## ORIGINATION FORM

### Proposed Revisions to a Standard Plans Index

Index Number: 653-001

Index Title: Pedestrian Control Signal Installation Details

LAST REVISION 11/01/20	REVISION	DESCRIPTION:	 FY 2023-24 STANDARD PLANS	PEDESTRIAN CONTROL SIGNAL INSTALLATION DETAILS	INDEX 653-001	SHEET 1 of 1
---------------------------	----------	--------------	---	---	------------------	-----------------

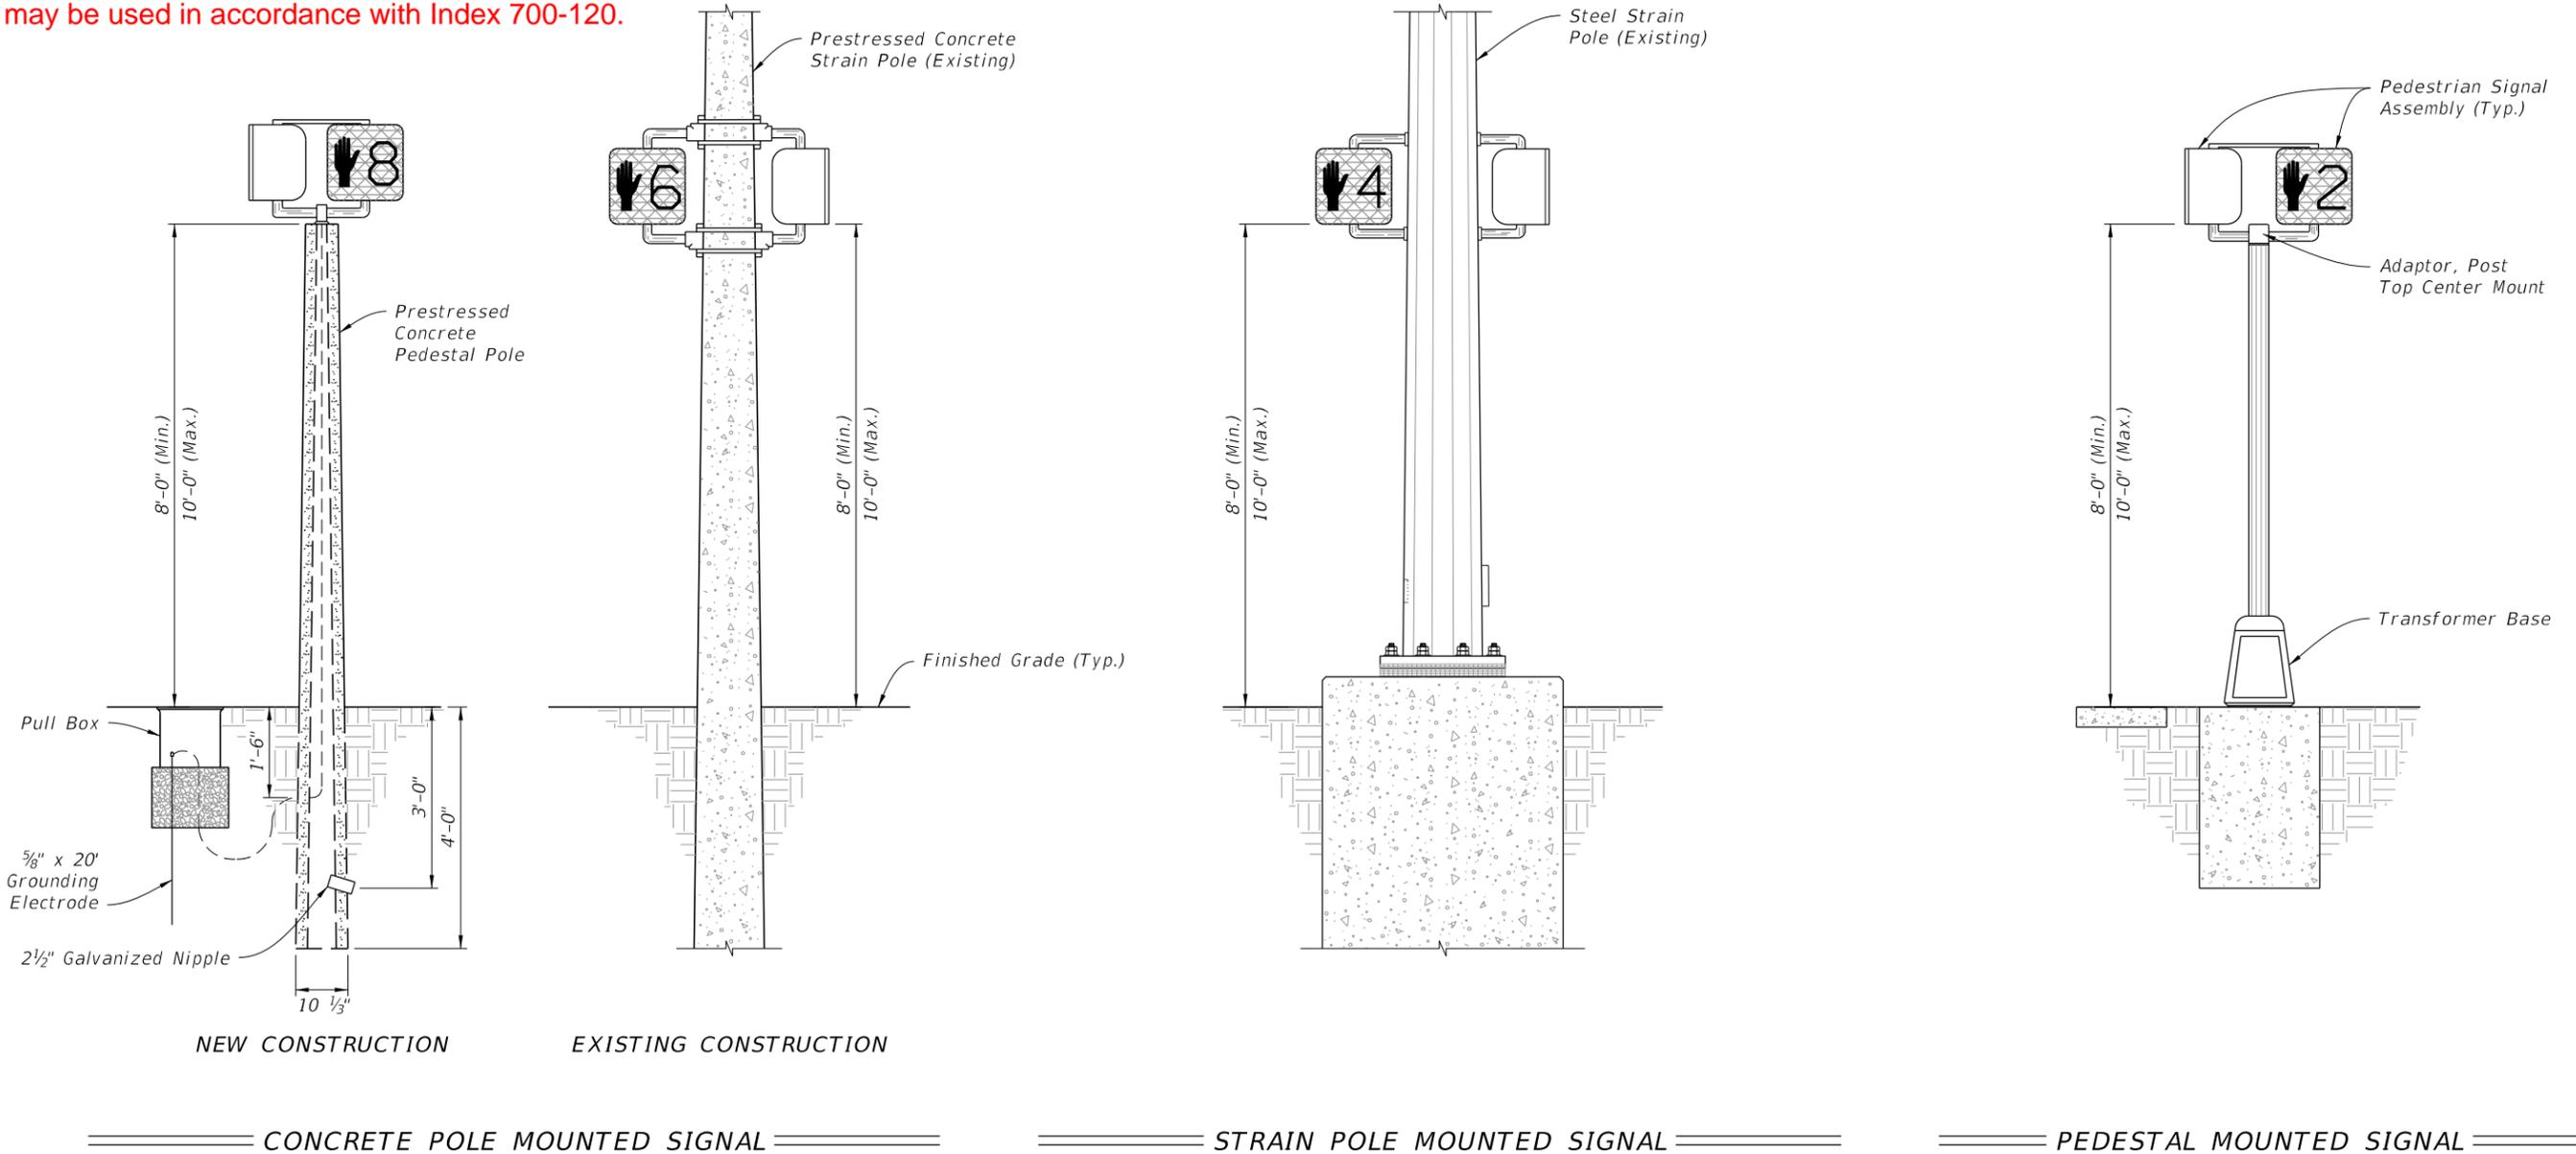
**8. In lieu of footing design shown, a Spread Footing may be used in accordance with Index 700-120.**

LAST REVISION	11/01/23	DESCRIPTION:	 FY 2024-25 STANDARD PLANS	PEDESTRIAN CONTROL SIGNAL INSTALLATION DETAILS	INDEX	SHEET
					653-001	1 of 1

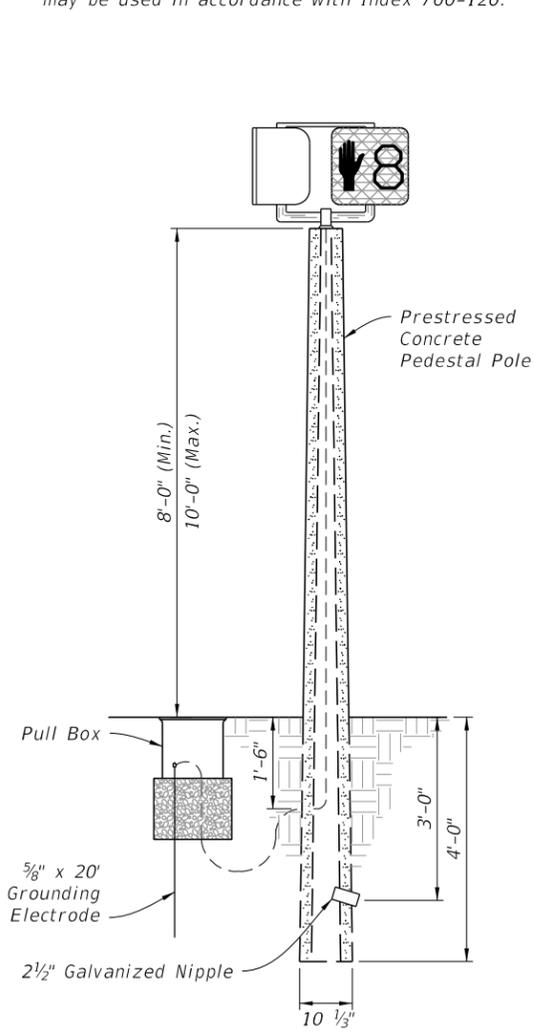
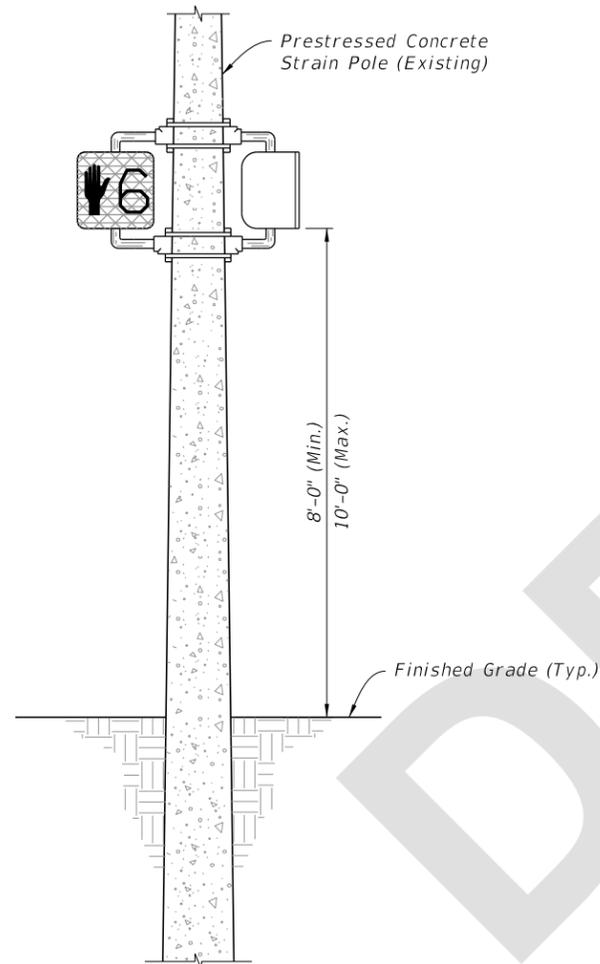
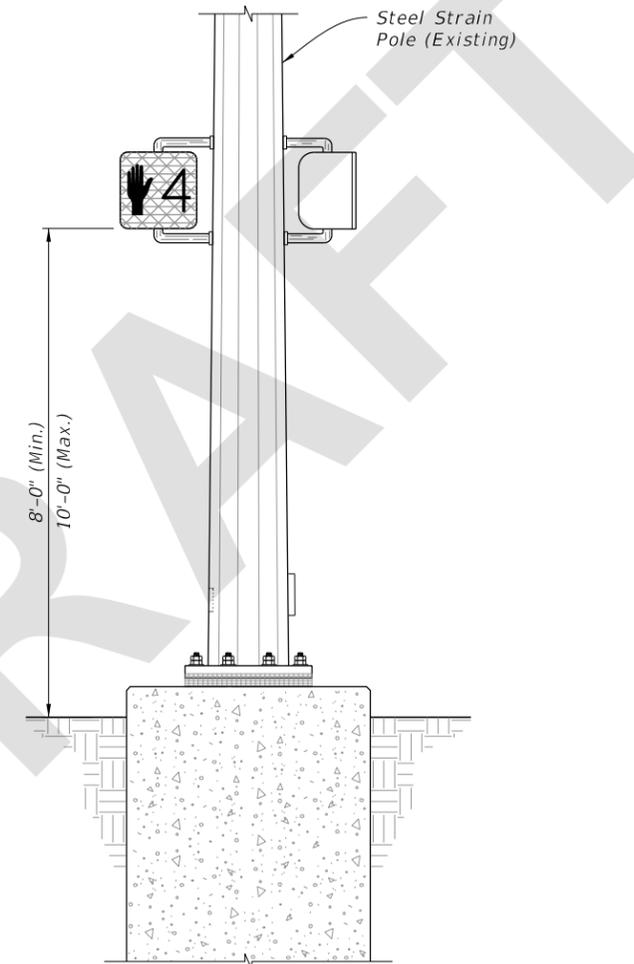
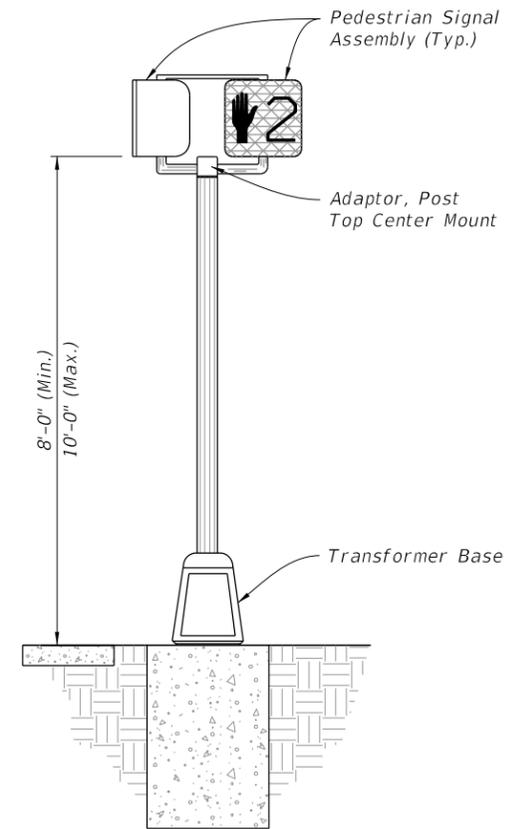
1. As an option, pedestrian signals may be installed on concrete poles and pedestals using lead anchors (two bolts same size per hub) in lieu of the stainless steel bands.
2. Repair drilled or punched holes in galvanized steel poles or pedestals in accordance with Specification 562. Install grommets or bushings in each hole.
3. Meet grounding requirements of Specification 620.
4. See APL for Department-approved Pedestrian Signal Assemblies and hardware.
5. For Prestressed Concrete Poles see Index 641-010.
6. For Steel Strain Poles see Index 649-010.
7. For Pedestal Mounted Signal posts and foundations see Index 646-001
8. In lieu of footing design shown, a Spread Footing may be used in accordance with Index 700-120.
